SUBJECT: Triangle Expressway Southeast Extension (Complete 540) from NC 55 Bypass in Apex to US 64/264 (I-87) in Knightdale, Wake and Johnston Counties; Federal Aid No. STP-0540(19), STP-0540(20), and STP-0540(21); WBS Nos. 37673.1.TA1, 35516.1.TA1, and 35517.1.TA1; STIP Project Nos. R-2721, R-2828, and R-2829

From: [Williams, Andrew E CIV USARMY CESAW \(USA\)](#)
To: [Riffey, Deanna](#)
Cc: [Alsmeyer, Eric C CIV USARMY CESAW \(USA\)](#); [Matthews, Monte K CIV USARMY CESAW \(USA\)](#); [Williams, Andrew E CIV USARMY CESAW \(USA\)](#)
Subject: [External] SAW-2009-02240 R-2721A Individual Permit Modification--MOD9
Date: Tuesday, September 13, 2022 10:39:18 AM
Attachments: [R-2721A Permit Drawings 06292022.pdf](#)

Subject: MODIFICATION of 401 Water Quality Certification Pursuant to Section 401 of the Federal Clean Water Act, NEUSE BUFFER RULES, and ISOLATED WETLANDS PERMIT Pursuant to IWGP100000 with ADDITIONAL CONDITIONS for Proposed construction of the Triangle Expressway Southeast Extension (NC 540) in Wake & Johnston Counties, Federal Aid Project No. STP-0540(19-21), State Project No. 37673.1.TA2, TIP Nos, R-2721, R-2828, & R-2829.
NCDWR Project No. 20181249 version 10

PERMIT

PERMIT DRAWING
SHEET 15 OF 119

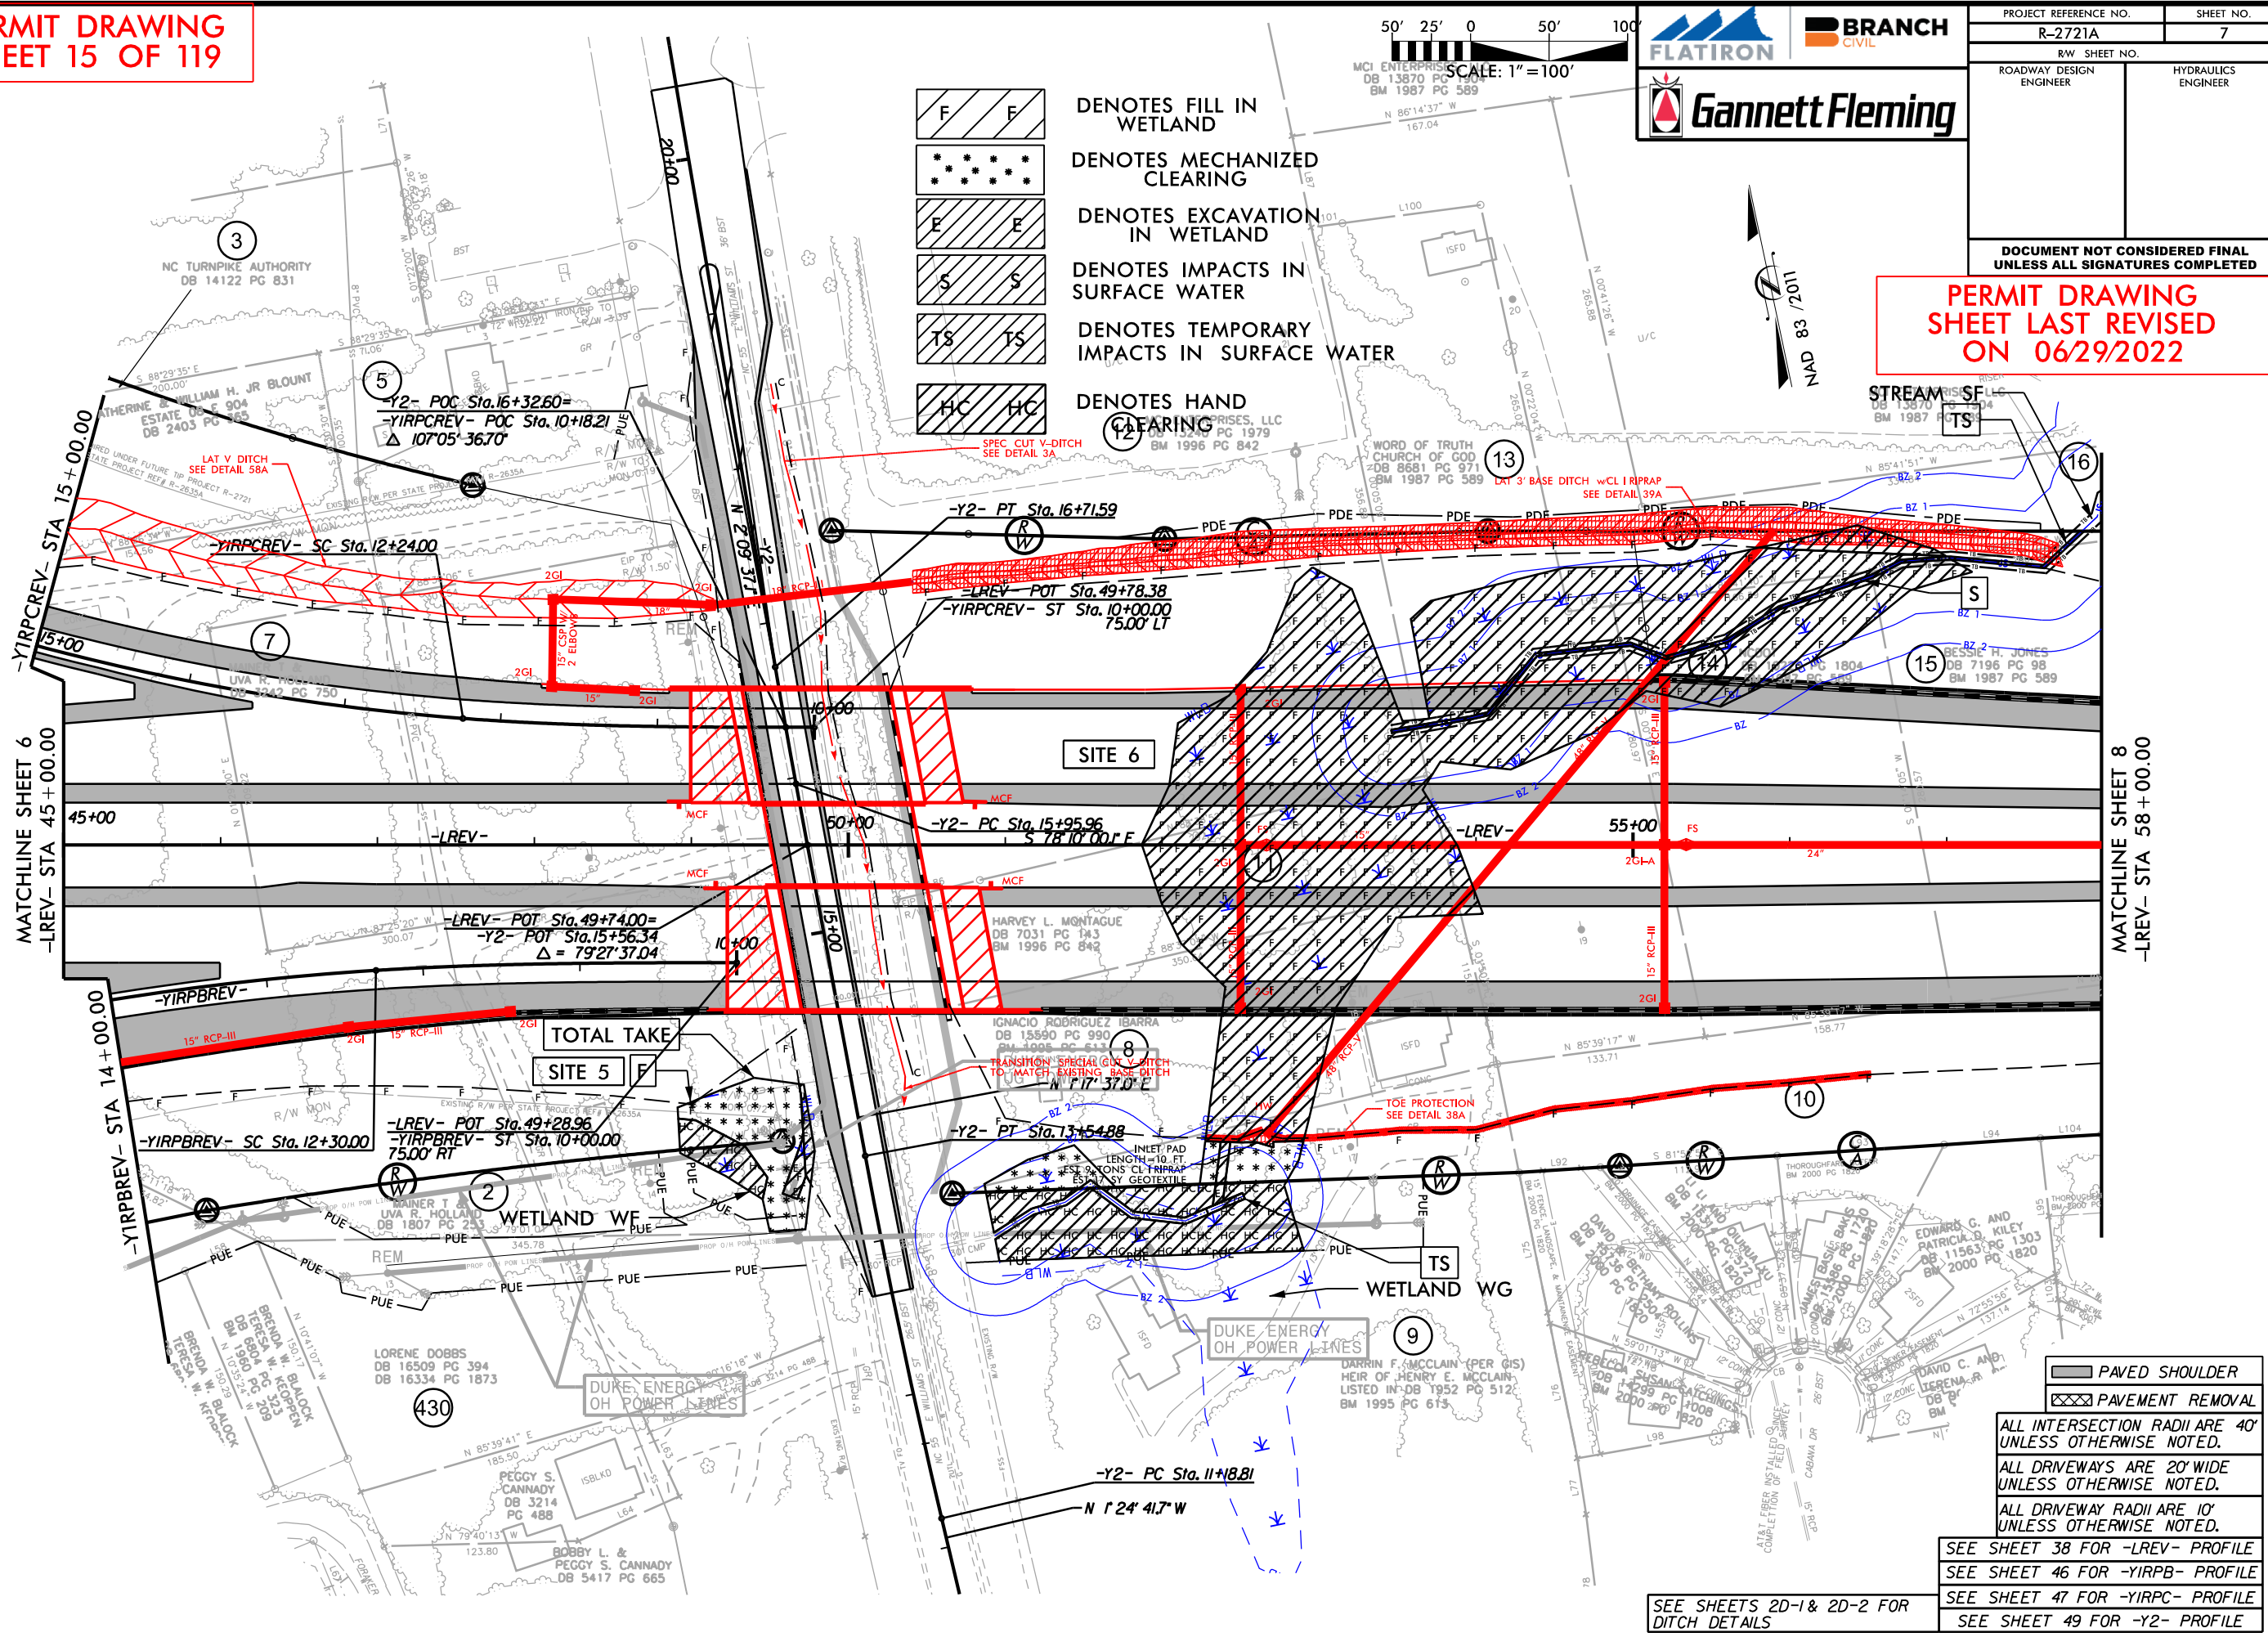
Site 6- 0.01 acre that were previously permitted as excavation would be permanently filled.

Site 6: 0.01 acres Excavation changed to Permanent Fill.

Revised Site 6 Total Impacts: 1.58 ac Permanent Fill. 0.03 ac Excavation. 0.06 ac Mechanized Clearing. 0.18 ac Hand Clearing.
